From: Maloney, Mike
Sent: Tuesday, November 28, 2017 10:25 AM
To: _PLANCOM - Planning Commission
Subject: FW: 11/30 PC Item 8.1
Attachments: Photo Sims - Emerald Isle.pdf

Attached, please find “before and after” photo renderings for the Emerald Isle project, Item 8.1 on Thursday’s agenda.

I am writing to you regarding Project File Number PRJ17-031, consisting of a Conditional Use Permit and Hillside Development Permit for Oakmont of Emerald Isle (Project) at 0 Gullane Drive to be considered at the Special Planning Commission meeting on Nov. 30, 2017.

Re: Planning Commission Agenda Items 8.1 and 8.4, 11/30/17 Meeting

Emerald Isle Photo Simulations by The Digital Realm

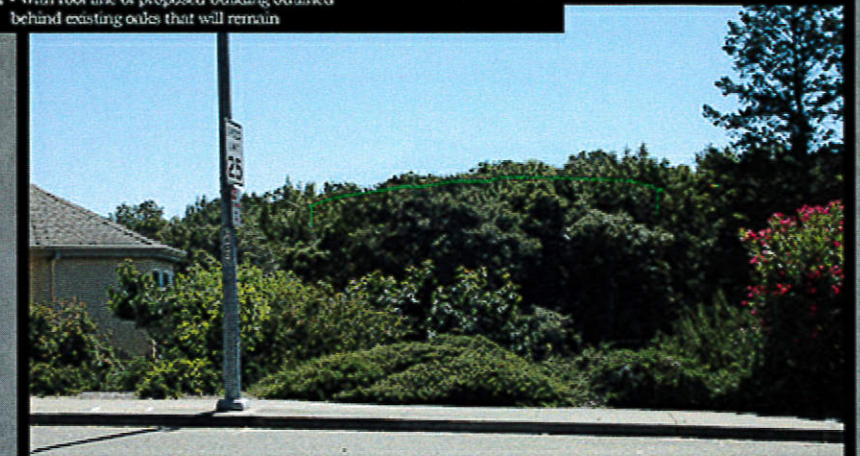
Potentially significant impact – The Project is located in an entirely undeveloped hillside which provides and serves as a scenic vista from the north/west. The Project will level approximately an acre and construct a two story building. This will significantly impact the views of this hillside which is primarily dense with trees and brush (outside the burned areas). This is not mitigated, addressed, or explained, how the design of the development does not detract from the existing open space in the immediate vicinity. The photo simulations are taken in April 2017, prior to the fire devastation, and not a relevant or accurate perspective or exhibit.
